2. Contract #3, London Avenue Outfall Canal, 1110-2-150a General Correspondence #3

5. PROJECT TITLE
 Lake Pontchartrain, Louisiana and Vicinity,
 High Level Plan London Ave. Outfall Canal,
 Parallel Protection, Mirabeau Ave. to Leon C.
 Simon Blvd. Floodwall, Orleans Parish,
 Louisiana

SPECIFICATIONS FOR LAKE PONTCHARTRAIN, LA & VICINITY, HIGH LEVEL PLAN, LONDON AVENUE OUTFALL CANAL, PARALLEL PROTECTION, MIRABEAU AVE. TO ROBERT E. LEE BLVD., WEST BANK; MIRABEAU AVE. TO LEON C. SIMON BLVD., EAST BANK FLOODWALL, ORLEANS PARISH, LA, ARE HEREBY AMENDED AS FOLLOWS:

SUBJECT: Lake Pontchartrain, Louisiana and Vicinity, High Level Plan, London Avenue Outfall Canal, Parallel Protection, Mirabeau Avenue to Robert E. Lee Blvd., West Bank Floodwall; Mirabeau Avenue to Leon C. Simon Blvd. Floodwall, East Bank Floodwall; Orleans Parish, Louisiana ED-94-144

**TYPICAL I-WALL MONOLITH
 CANAL SIDE TEXTURE FINISH**

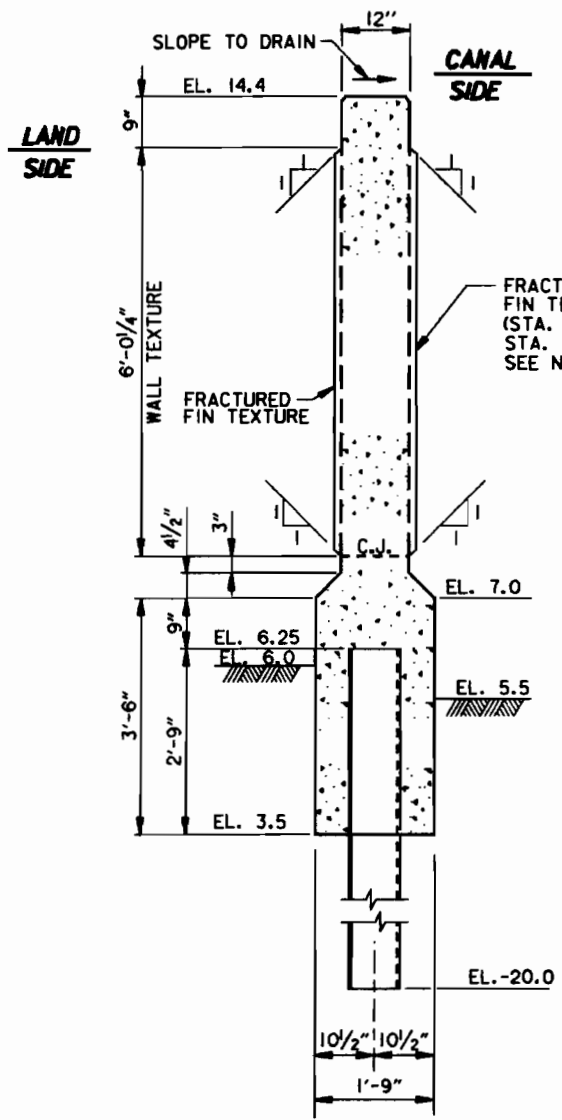
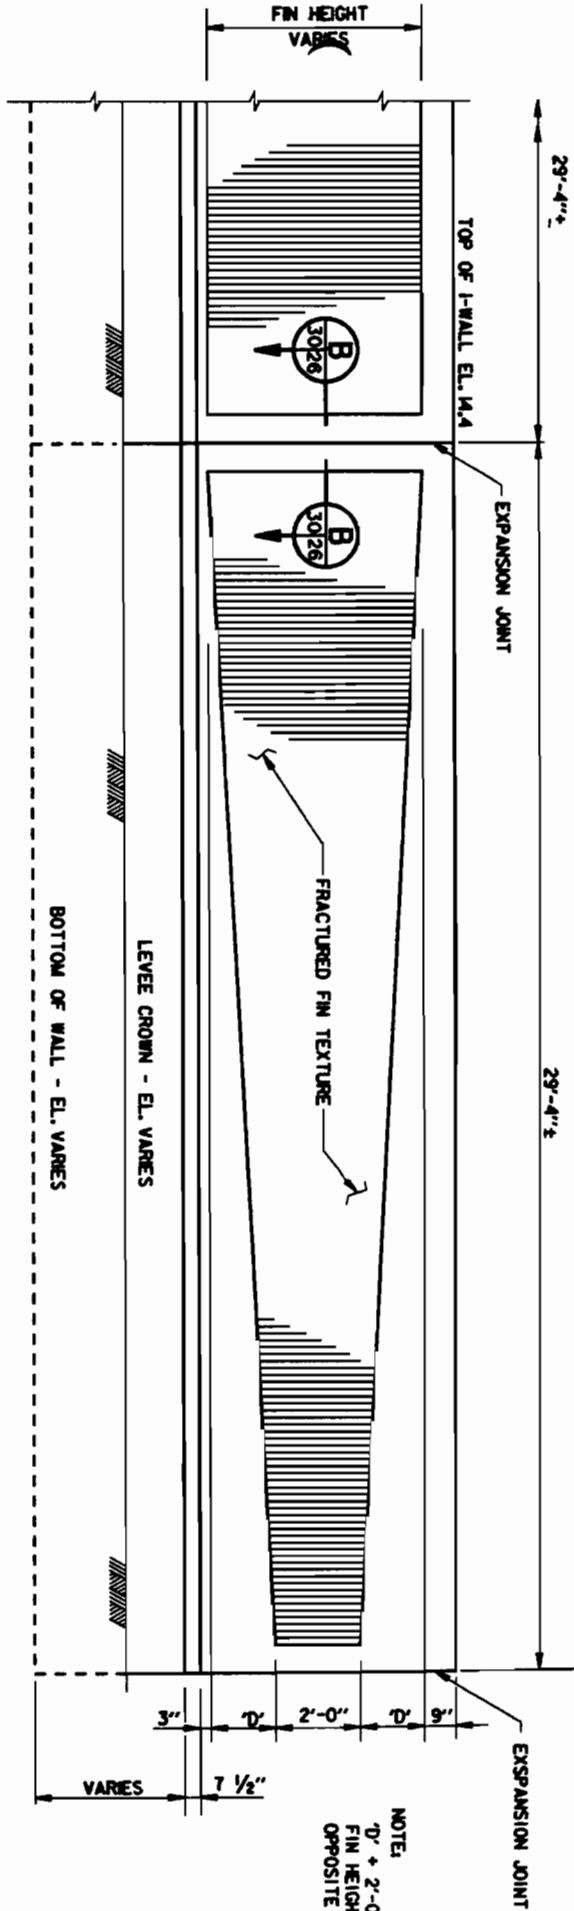
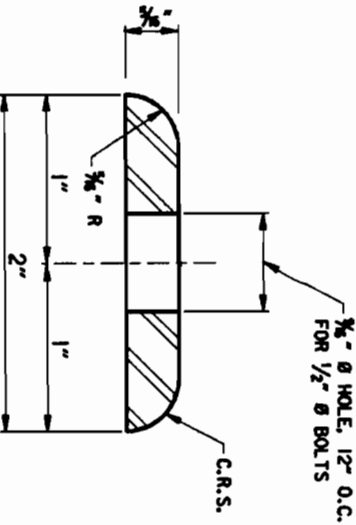
I also included one modified section. All other sections are done the same. For amendments, the title block change is the same as this one except "Mod #" becomes "amendment no. 1". You can abbreviate. Right now we are checking on the status of the job to see if we will just substitute or if an amendment needs to be done. I'll let you know as soon as I find out.

SECTION AT TELEPHONE CONDUIT

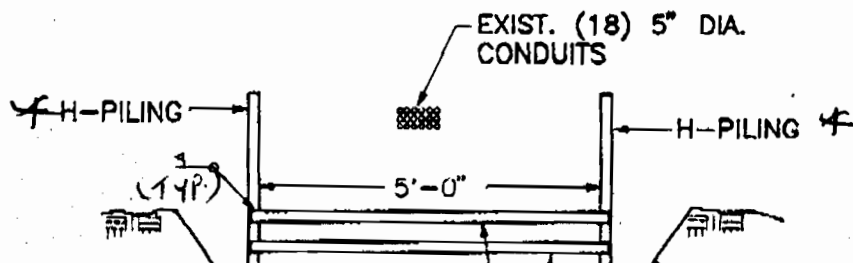
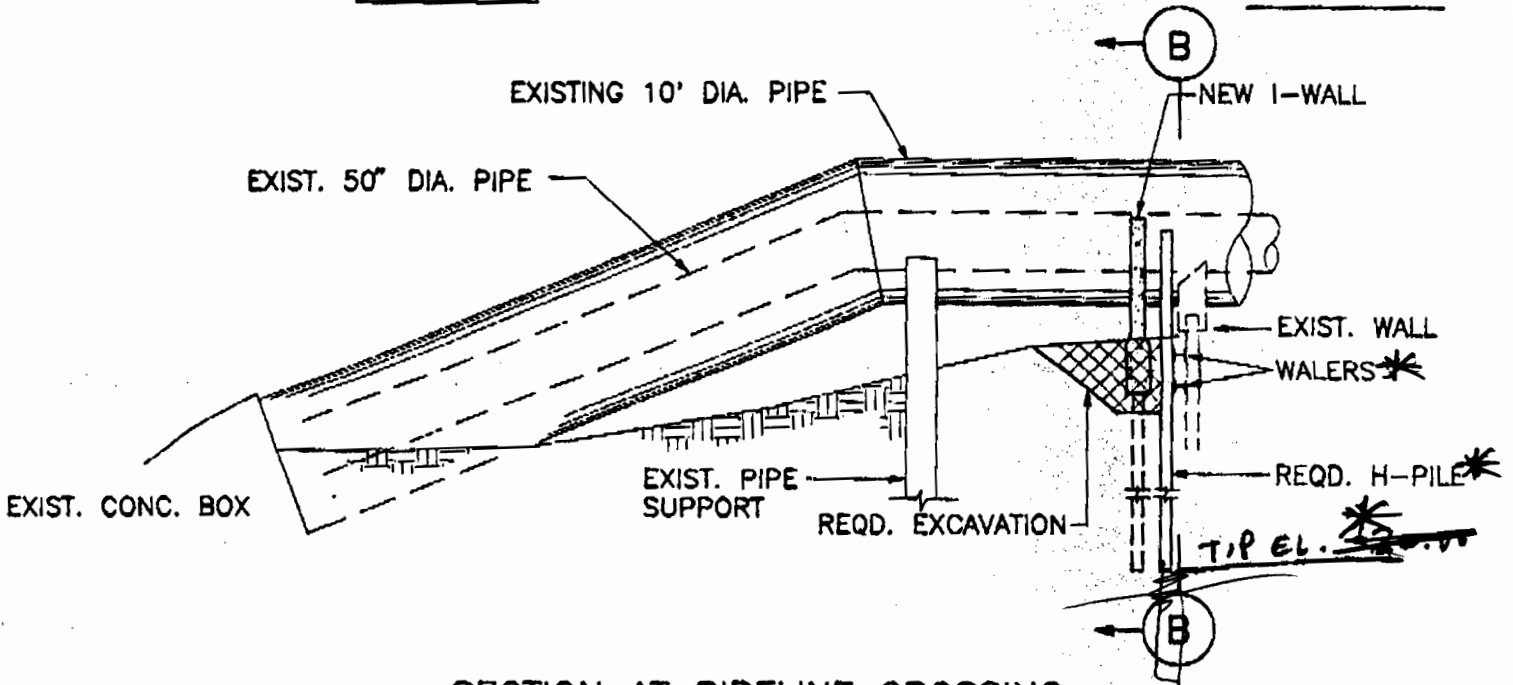
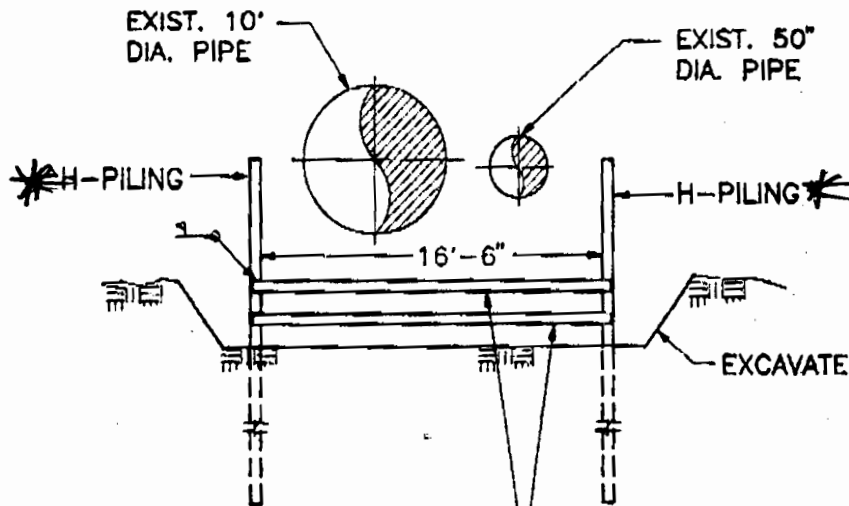
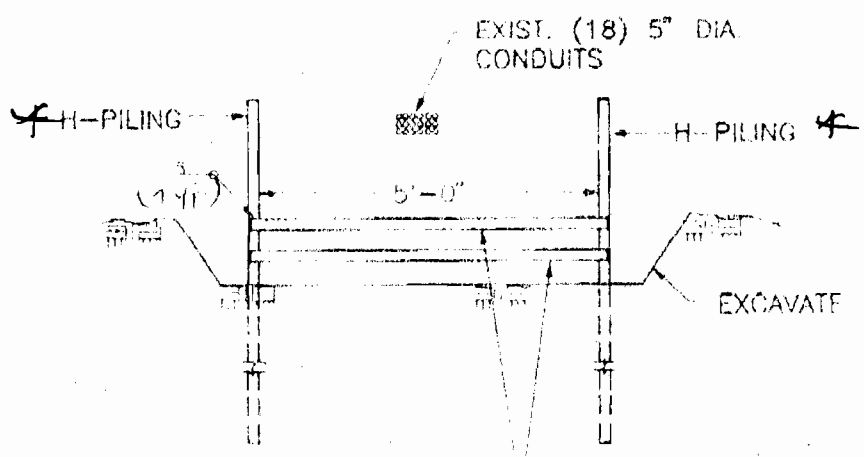
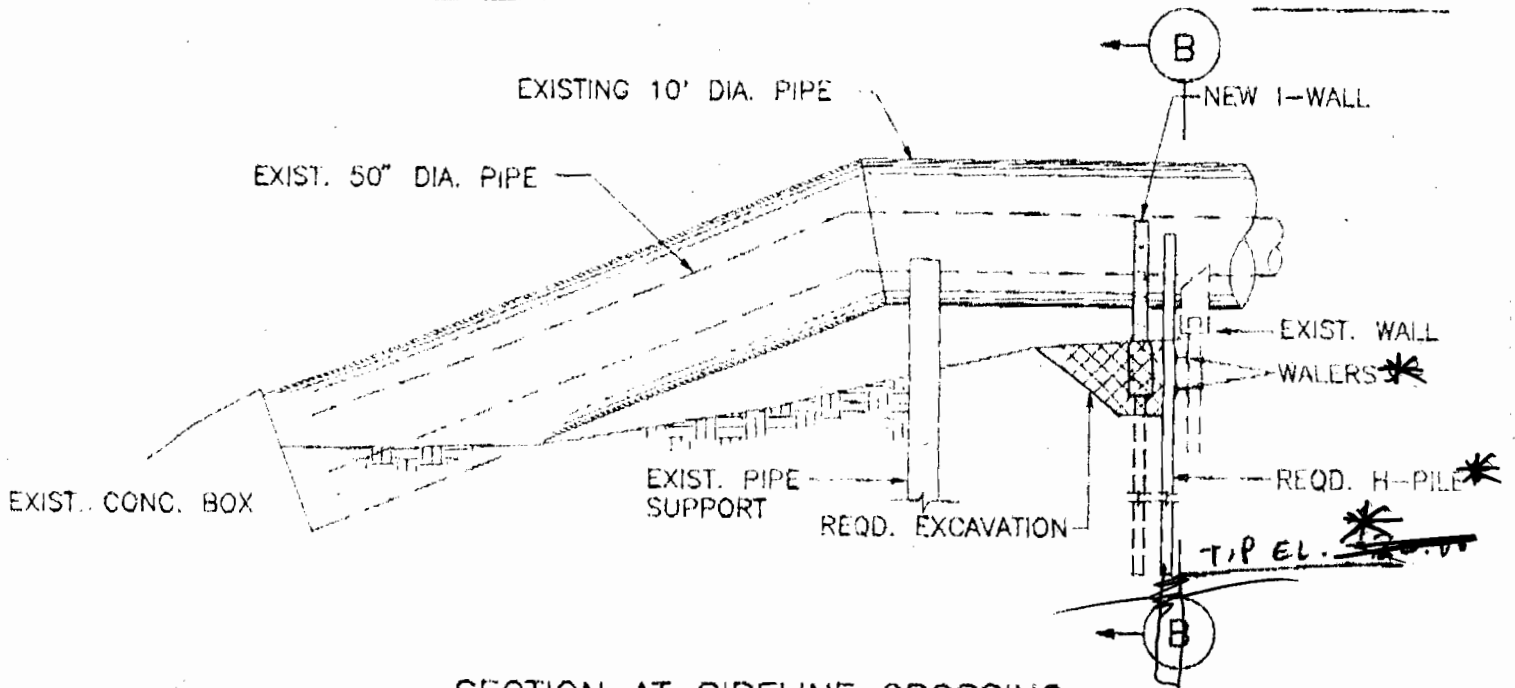
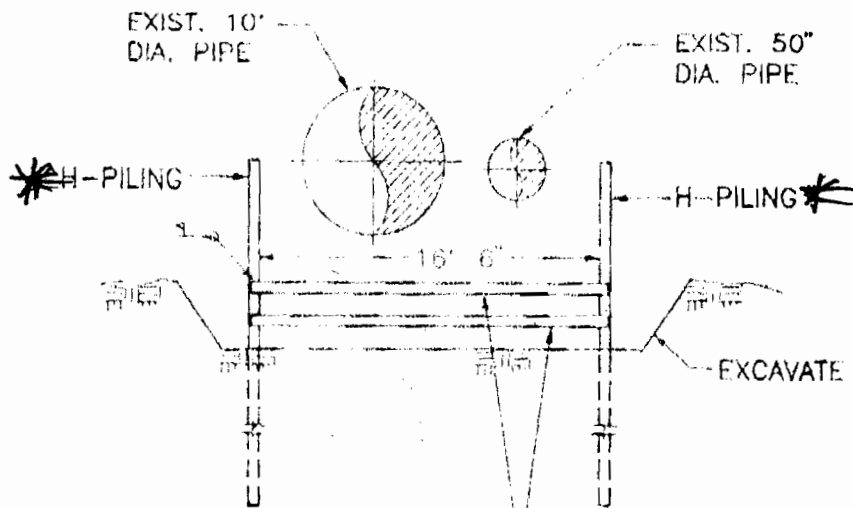
Message: Please review these details for the temporary bracing to protect existing piling during construction. Once I have your comments, then we cannot then send you the final plot files at the revised design. Please call me at 483-6278 or fax me your response. Thank you.
Shel Shah

CONTRACTOR SHALL FIELD VERIFY
 DIMENSIONS REQD. ~~SIZE WALERS~~
 TO ~~MATCH H-PILE TO EXIST.~~
~~SHEET PILE SPACE.~~

REQD. STEEL WIDE FLANGE *
 WALERS AT 1/3 POINTS
 OF EXCAVATION

Add note
